Discontinued Availability Notice Ribbon Combination and Splice Shelves

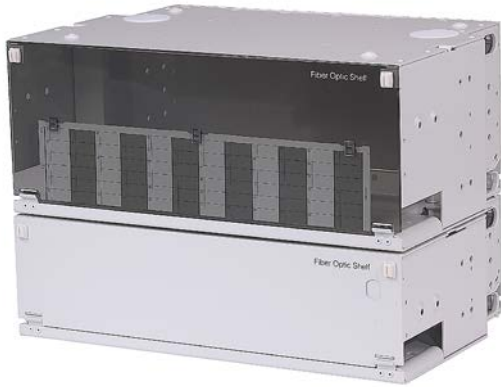
LSR1U-072/12 105361430 Replaced by LSC00-072-12-E/W(1)LT1B-MF (300517232)
LSR1U-144/19 105361422 Replaced by LSC00-144-14 (300447125) and one tray LT1B-MF (300386935)
LSS1U-215/5 105361448 Replaced by LSS1U-072/5 (105335806) and one tray LT1B-MF/MF (300386935)

Reason for the change: New offerings are a more cost effective solution. The replacement shelf LSC00-072-12-E/W(1)LT1B-MF (300517232) comes equipped with one mass fusion splice tray. The bottom portion of the combination shelf is the splice shelf. The splice shelf can handle 3 splice trays either mass fusion or single fusion splicing by selecting the splice tray LT1B-F/F (300386919) for single fusion and LT1B-MF/MF (300386935) for mass fusion. The single fusion tray will secure 48 single fusion splices and the mass fusion tray will secure 18 mass fusion splices (216 fibers when using the 12 fiber mass fusion splice)

Combination shelf : One termination shelf and one splice shelf. The termination shelf can handle 96 (8 port panel) terminations or 72 (6 port panel) terminations. Shelves are available empty or equipped with (E/W) panels, adapters and splice trays.
